2010 PUMP STATION REHABILITATION
KINGS ROW 1 PS
CIVIL SITE AND MECHANICAL PLANS

SHEET NUMBER
C2
 9 OF 48

2010 PUMP STATION REHABILITATION
QUEEN WAY PS
CIVIL SITE AND MECHANICAL PLANS

K:\2009-TO CAPITAL PROJECTS\04-189 2010 Pump and PRV Rehab\04-189 Kingsrow C2-addendum 2.dwg
 Jan 20, 2010 11:55am

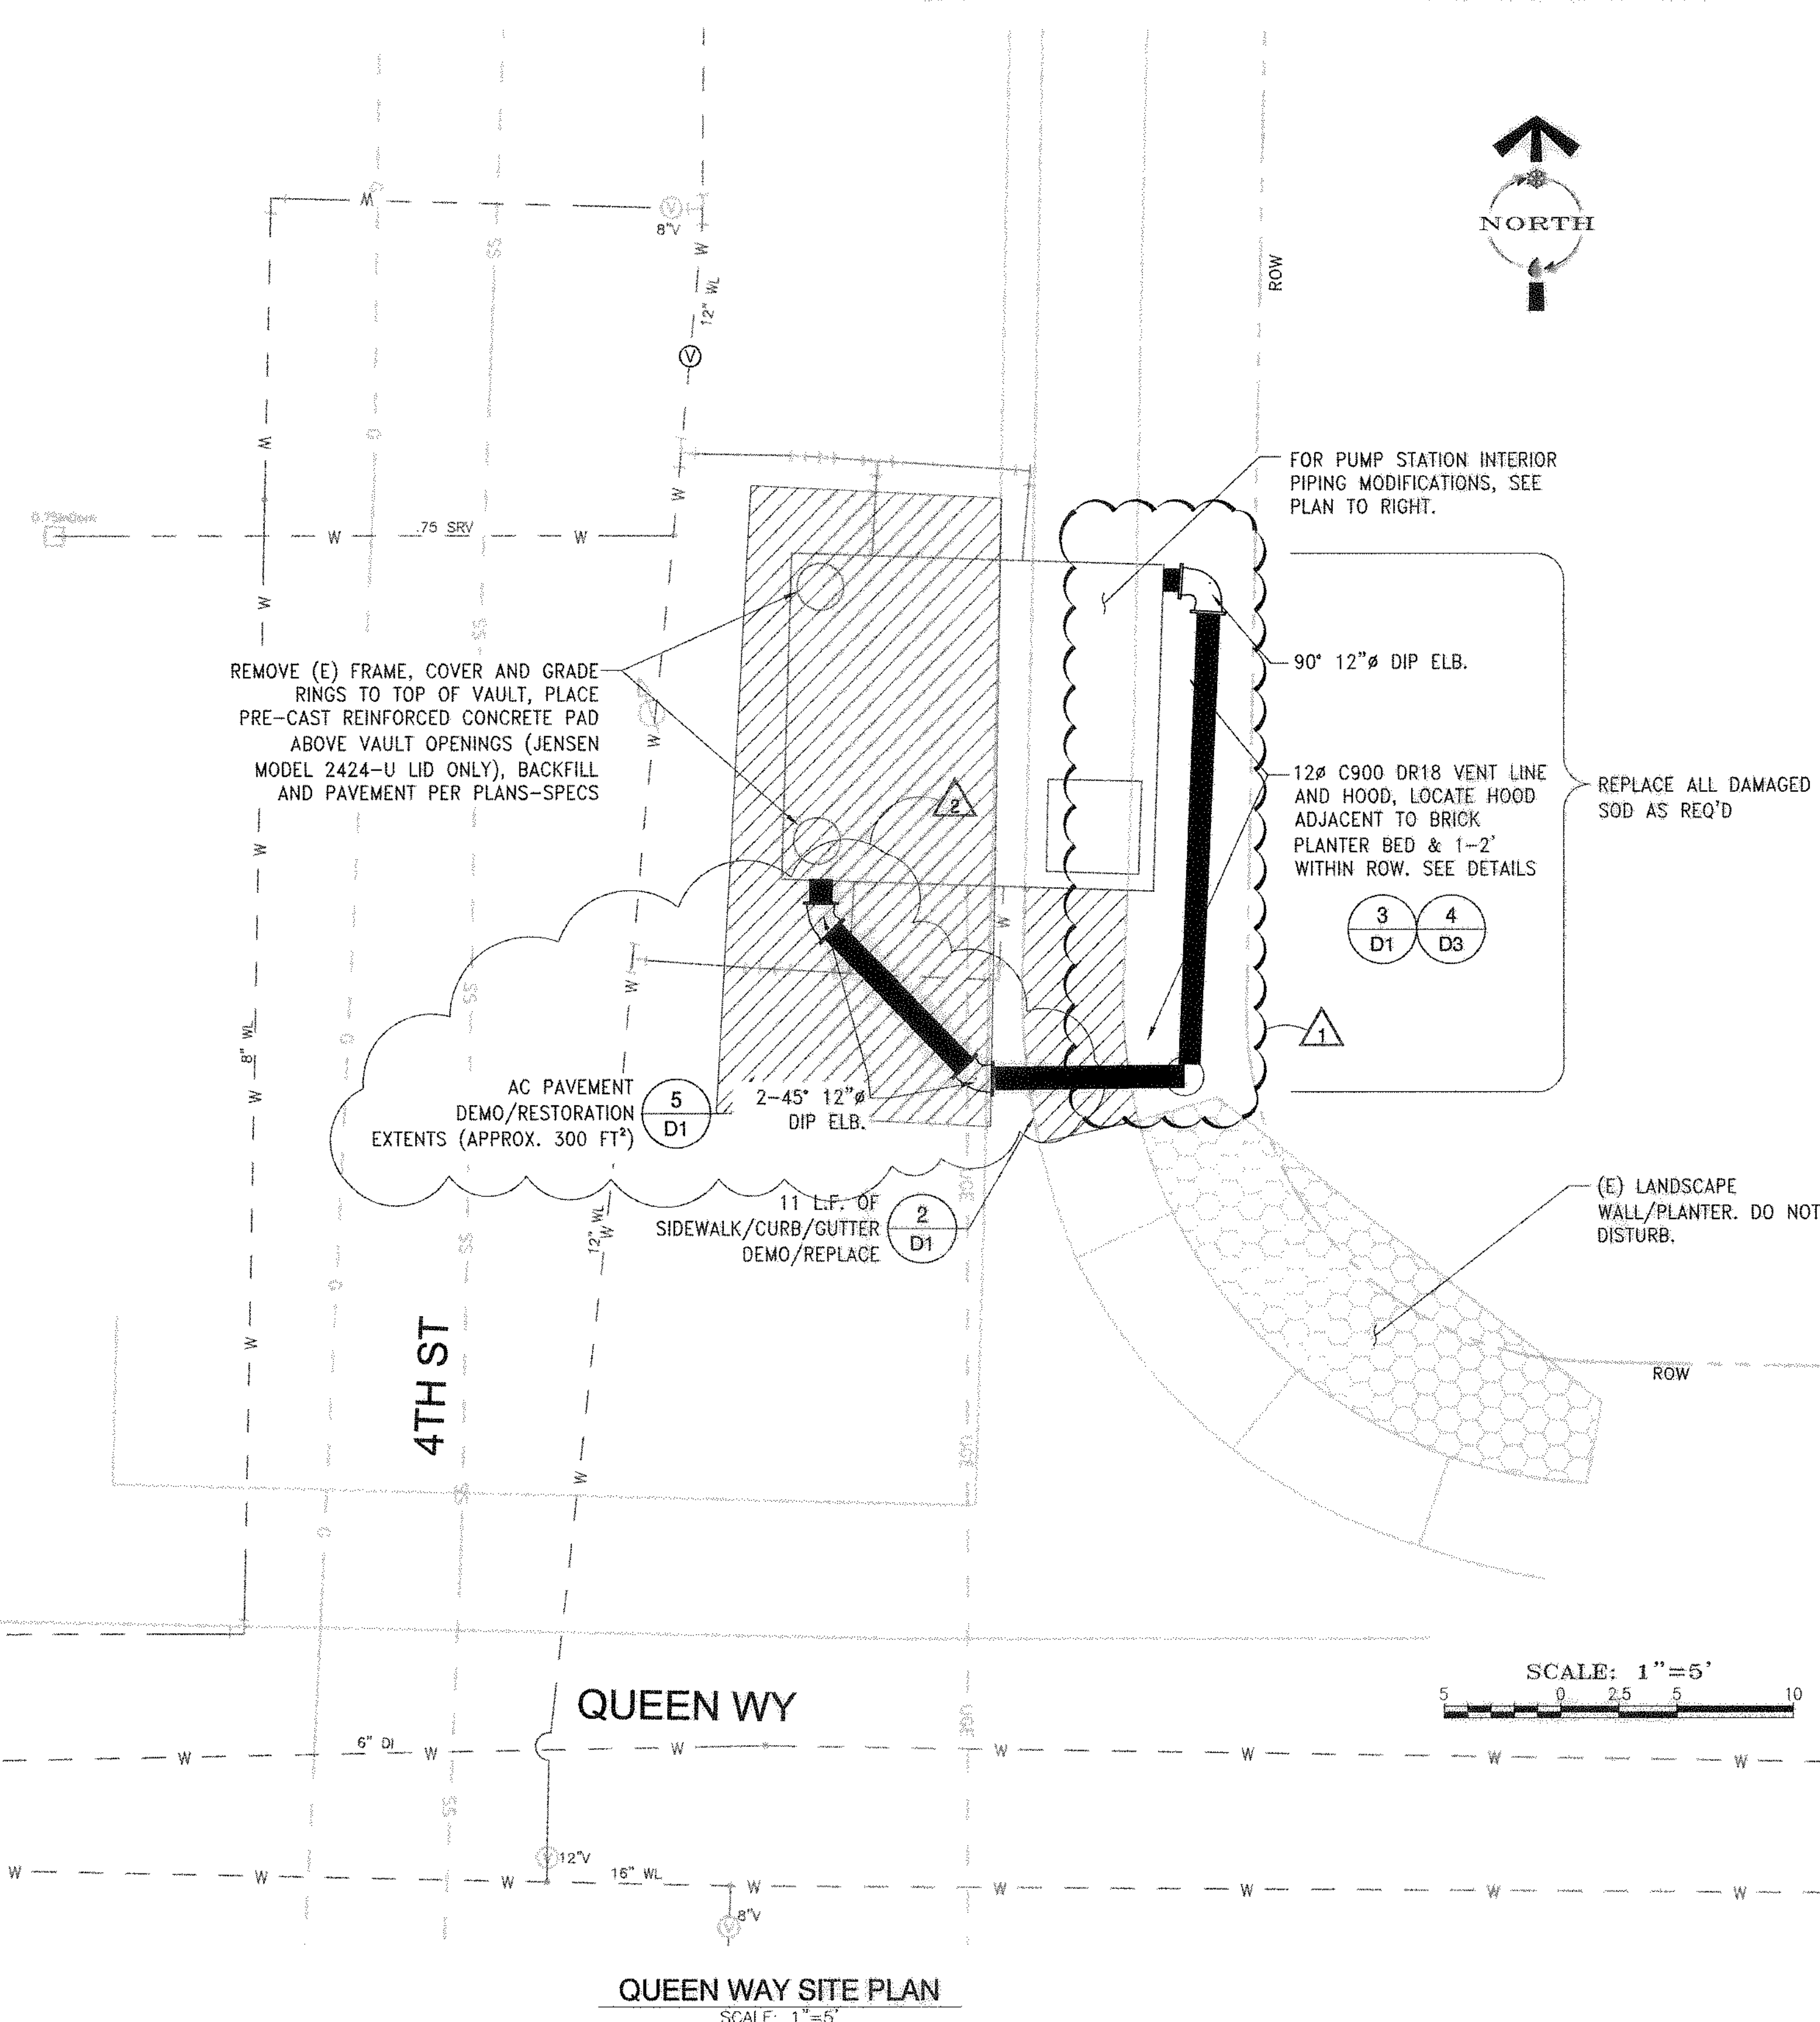
REVISION	DESCRIPTION	BY	APP	DATE
1	ADDENDUM #1	SB		1/10
2	ADDENDUM #2 - REVISED VENT INTAKE INTO VAULT LOCATION, ADDED	SB		1/10
	PIPING AND ELBOW AND INCREASED AC RESTORATION AREA
